EXECUTIVE SUMMARY

The proposal is a modification to MP08_0244 MOD1 and primarily serves to incorporate an additional site, being part of the former Council car park site at 9 Havilah Lane. The FSR is effectively the same. The proposal has slightly increased in height along the Havilah Lane frontage as land falls away beneath the building whilst the previous roof/parapet heights have been maintained as the building has been extended. The basement car park levels have been extended and incorporate 37 additional car spaces. The commercial loading dock and goods lift has been relocated. The retail area has been increased by 341m², primarily to enlarge the major retail tenancy. 10 additional units have been added (2 per floor to the northern end of the Havilah Lane tower) and the mix has been altered by incorporating more 3 bedroom units (previously 1.7%, now 5.7%).

The proposal is not supported in its present form.

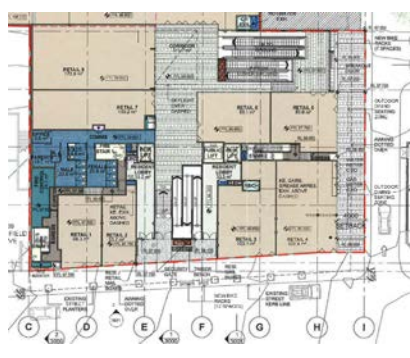
Similar amendments that were disputed and rectified in the approval of MOD 1 are again being included in this proposal with regards to the Lindfield Avenue frontage. This MOD2 documentation (drawing 1004C) shows that the ground floor retail to Lindfield Ave has been set back approximately 1.5m and ramp access has been incorporated leading from the corner of Kochia Lane to the main Lindfield Avenue building entrance. This ramp is considered to be obstructive and prevents direct interaction with the Lindfield Avenue footpath for approximately 21m of the 44m frontage (44%) (drawing 0002C). In addition, the slanted column at the Kochia Lane corner is an obstructive protrusion that does not allow free passage by pedestrians. Such building elements should be included within the building envelope to ensure clutter free frontages to the public domain and to avoid elements that obstruct visibility, creating pockets of entrapment.

As previously stated and agreed by the Department in Council's submission to MOD 1, the location of this access ramp across the street frontage of Lindfield Avenue is unacceptable as it prohibits any connection of the footpath with those retail premises and the building

entry. The location of numerous stairs directly off the footpath is a poor and hazardous feature with the obvious issues of the merging of footpath traffic and traffic exiting the building. A suitable distance should be provided adjacent to the footpath to avoid conflict between the pedestrian flows.

Further, this proposal does not comply with the requirements of the street activation clauses in both the KLEP Local Centres 2012 (cl 6.6) and the Ku-ring-gai Local Centres DCP. It is again argued that all retail premises facing Lindfield Avenue and Kochia Lane are to demonstrate street activation measures by having shopfronts on the property boundary line with direct level access off the footpath to the individual premises. Any changes in level necessary to access the interior of the building should occur within the building itself as was done in the amended and approved MOD 1 proposal (see diagrams below).

It is recommended that the previously Approved MOD 1 address to Lindfield Ave be reinstated to ensure street activation of Lindfield Avenue, and consistency with the existing and future street frontage developments that will be required to comply with street activation and access clauses in both the KLEP LC 2012 and the Local Centres DCP.

It is recommended that that the access ramp on the Lindfield Avenue frontage be deleted and relocated to a location within the building arcade area to enable the required active street frontage and interaction between the inside of the building and the external public areas.

It is recommended that the shopfronts Retail 3, Retail 4 and the residential lobby be brought forward to the street boundary line to keep the important street wall and immediate level access to entries consistent with other frontages to Lindfield Ave.

It is recommended that direct level access be provided from the street footpath to all

retail, commercial and building entrances including to the Retail 3, Retail 4 and the residential lobby to Lindfield Ave.
